## Historic Landmarks and Preservation Districts Commission

# Report to the Committee

**Case No:** 23-COA-0054  
**Classification:** Staff Review

**Property Address:** 1436 S. Brook Street

Figure 1. 1928 Sanborn Fire Insurance Map (Vol. 5, Sheet 529).

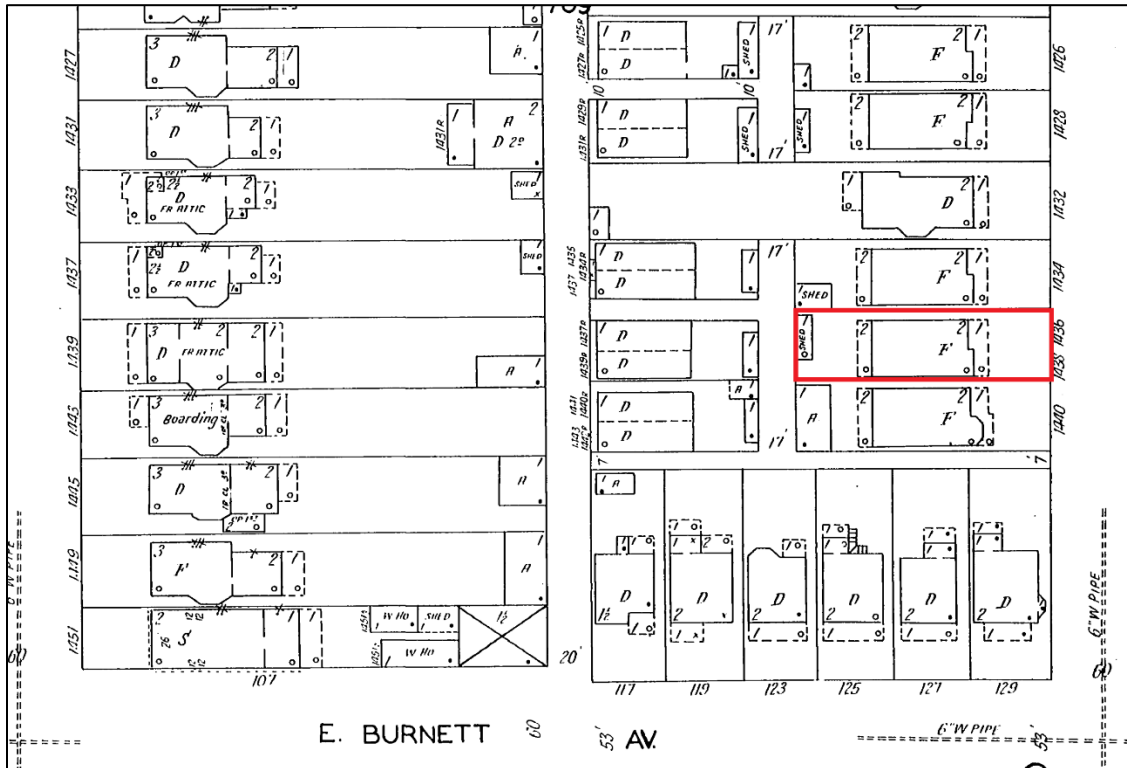
The property is located on the west side of S. Brook Street three lots north of E. Burnett Street. The house is zoned TNZD and located within the Traditional Neighborhood Form District. The two-story, frame Colonial Revival Style house, built circa 1910, was historically a duplex (**Figure 1**). The 1920 Sanborn Map shows the building with two addresses and it's labeled as "F" for Flat, which mean more than one dwelling unit. The right side of the building, known as 1436 S. Brook, was the upstairs flat. The left side, known as 1438 S. Brook, was the downstairs flat. Real estate ads in the *Courier-Journal* from 1910 and on show the two separate flats. Furthermore, the architecture and form of the building clearly shows that it was built as a duplex.
